**CITY OF MANHATTAN BEACH
DEPARTMENT OF COMMUNITY DEVELOPMENT**

SUBJECT: Consideration of a Substantial Change to Approved Site Development Permit Plans for Fire Department Check-Valve Location for Eleven Residential Apartment Units at 1214 Tennyson Street (Van Zanten)

Subject: 1214 Tennyson Avenue, Fire Check Valve Location; Permit #18-00340

1214 Tennyson St.- Proposed Location of Fire Service Backflow Device

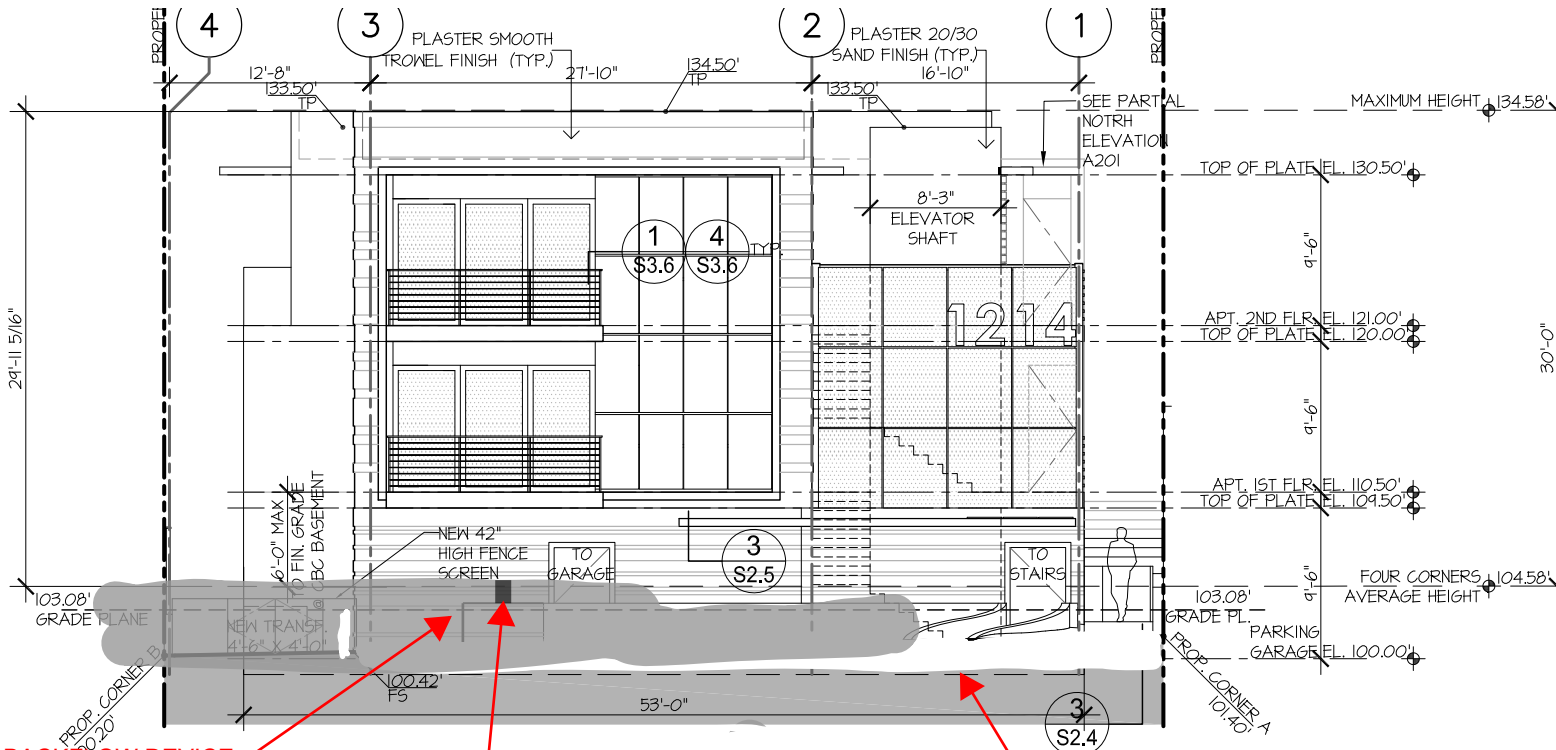
The current civil plans show the fire check valve located at the back of the property as requested by Eric Haaland; it is currently between the apartment building, an accessory parking structure and a down sloping driveway and can only be accessed through a side gate (see attached plan).

However, the water main for the property is on Tennyson Street. The current location on the plan places the fire check valve 178 ½ feet from the water main. The fire check valve this far away from the water main creates the following multiple issues:

- Bacterial Growth In The Pipes – Ductal iron and C900 plastic pipe will be installed from the water main at Tennyson to the fire check valve (178'5"). The ductal iron will allow for bacteria growth if the water is not flowing. This water will be flowing in and out of the pipe back in to the water main serving the neighboring properties.
- Friction Loss For The Sprinkler System/Water Pressure Drop – By the time the water reaches the system at the back of the property the drop in pressure will be about 60% of what it would be at the front of the building.

Suggested New Location:

Fire Safe Systems, the subcontractor, has recommended to us and to Eric Haaland that the best location would be at the front of the property and the fire check valve to be close to the Tennyson water main as possible. This location solves all of the problems created with the current valve location at the back of the property.

A-201

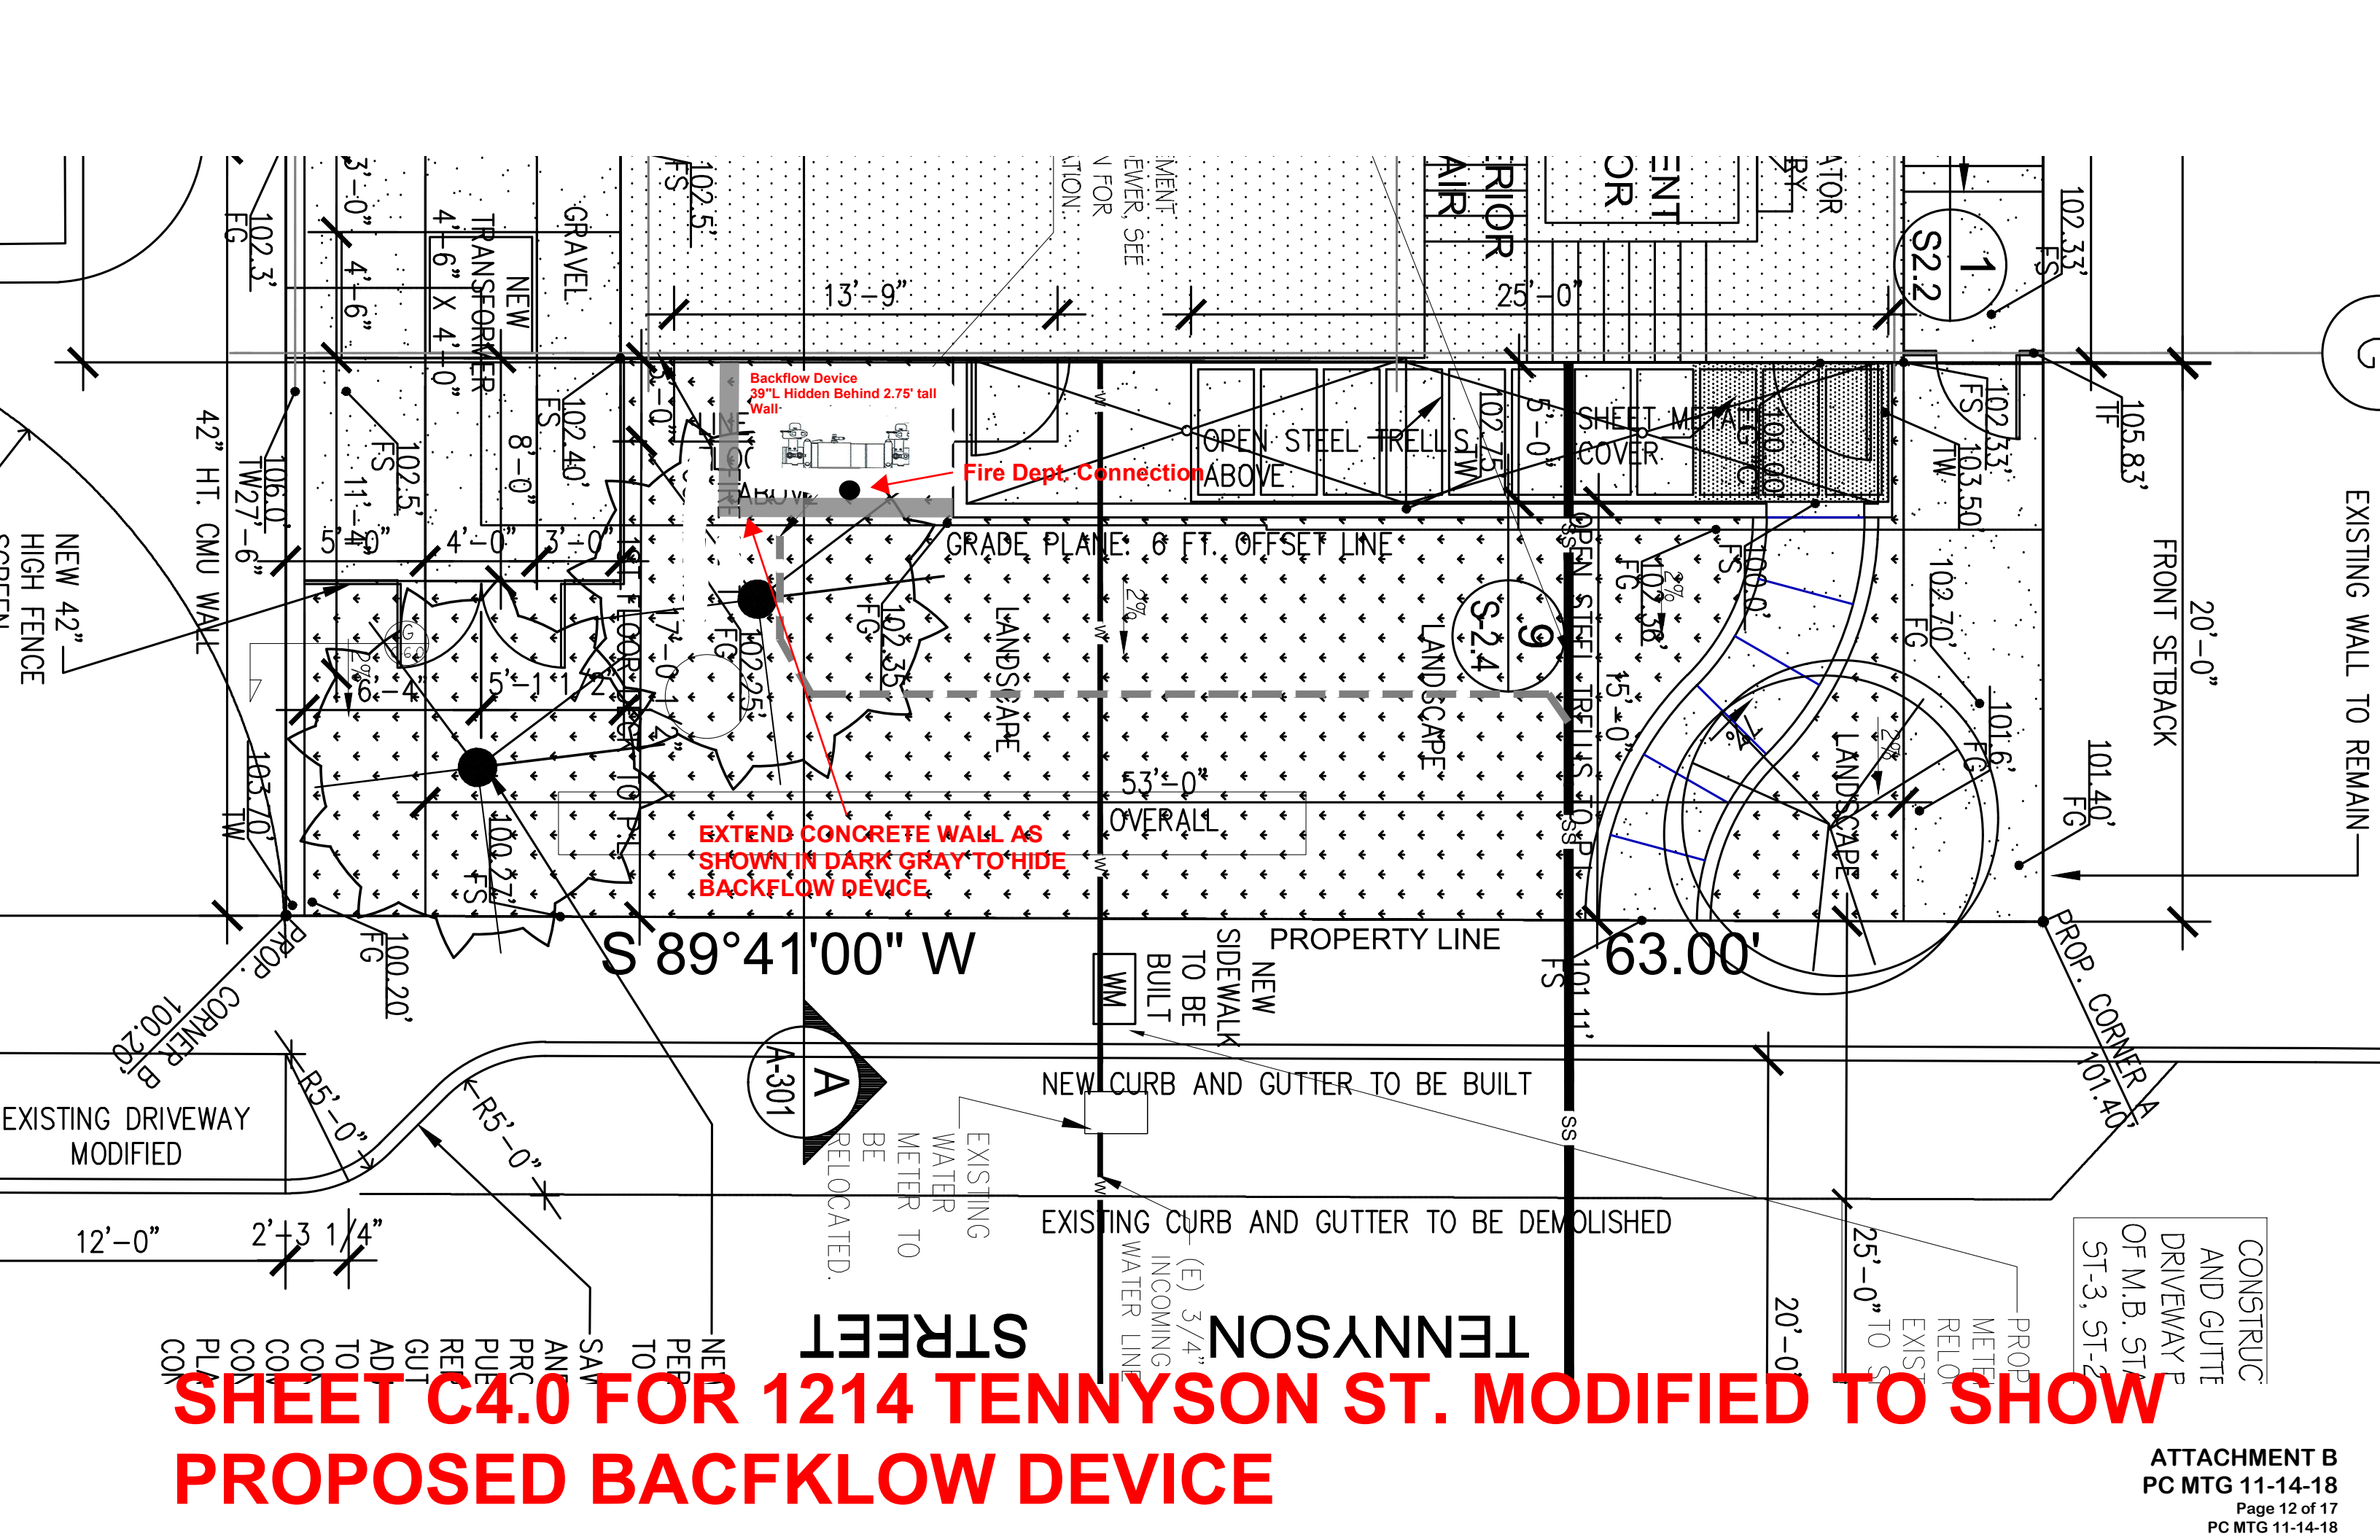
Screen the Valve

For aesthetics, we could install the fire check valve below the front landscape berm. As a help, I have added the cut sheets for the backflow. The valve would be 35" in width and 13" tall. A site plan with the new location and a side view of the fire check valve below the berm are attached.

FIRE BACKFLOW DEVICE HIDDEN BEHIND WALL

Fire Dept. Connection (FDC) Per Original Plan. Extend 18" Above Grade Per Fire Code
